APPLICATION NO.	FILING DATE		FIRST NAMED INVENTOR	ATTORNEY DOCKET NO.	CONFIRMATION NO
10/629,089	07/29/2003		John R. Hampton	41394-9USD1	6384
7:	590	03/19/2004		EXAMINER	
Margaret A. E	Boulwar	re	POPOVICS, ROBERT J		
Jenkens & Gilc Ste. 1800	hrist		ART UNIT	PAPER NUMBER	
1100 Louisiana	L		1724		
Houston, TX	77002		DATE MAILED: 03/19/2004

DETAILED ACTION

Figure One of Rowling.

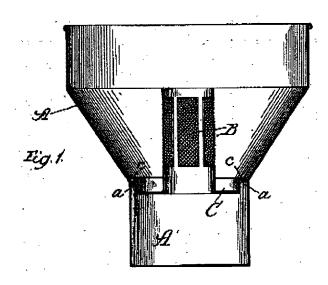
Rowling discloses a strainer assembly, however, the separation of a lighter and a heavier fluid is not expressly disclosed. Mohr discloses the use of a similar apparatus, to separate water from fuel (See Mohr at col. 1, lines 5-20, and col. 2, line 100 through col. 3, line 25). In view of the Mohr disclosure, it would have been obvious to employ the assembly of Rowling to separate heavier liquids from lighter liquids, since the two assemblies are so similar in design.
